<u>Preservation Department – Item 1, LPC-20-08010</u>

49-51 Chambers Street,

51 Chambers Street - Emigrant Savings Bank Building Public Meeting Presentation, 21 July 2020

01.3 Previous Proposal

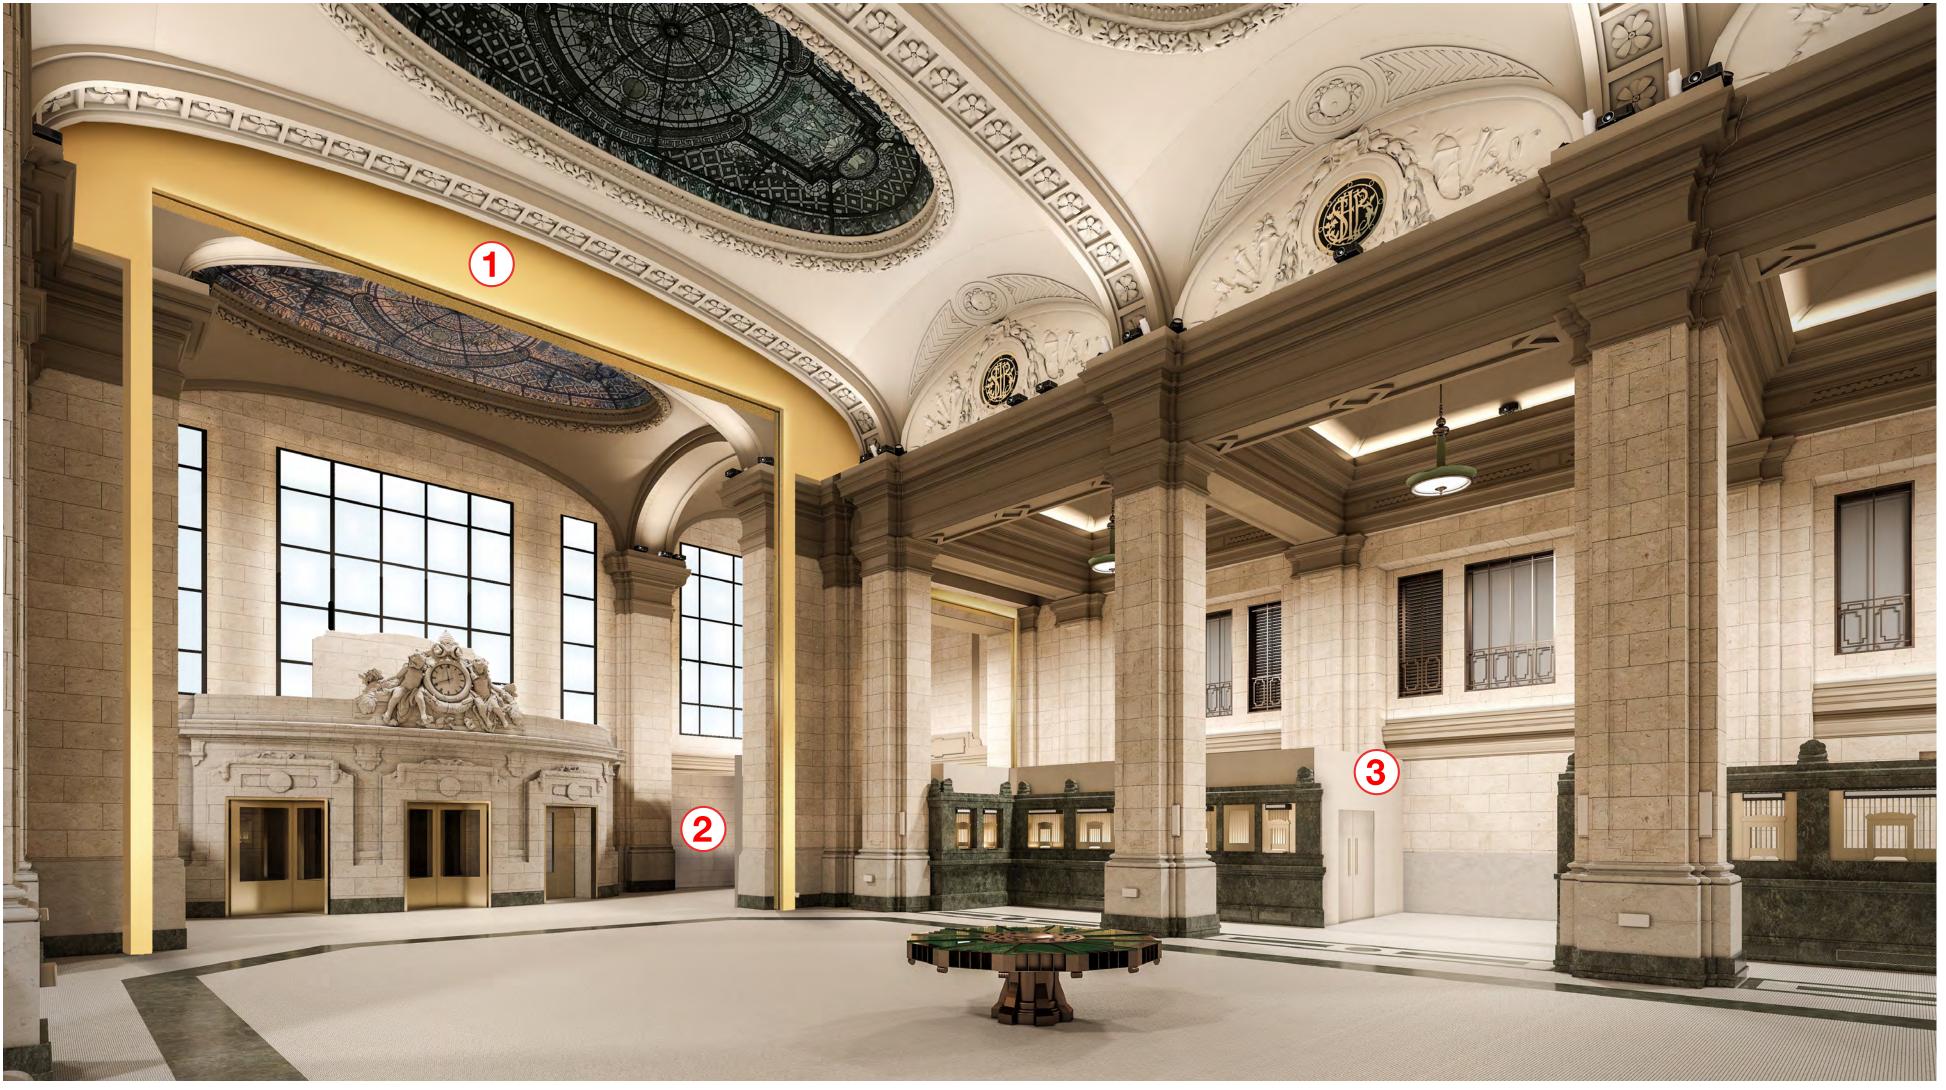
Commissioner Comments:

- 1 Blocking of windows
- Treatment of new construction (boxes)
- 3 Reuse of historic material
- 4 Extent of exterior signage

- Introduce interior curtain system to control light and sound. Chambers Street windows to remain uncovered at all times.
- 2 Eliminate new construction within designated areas.
- 3 All historic material to be removed will be salvaged and stored on site. No reuse.
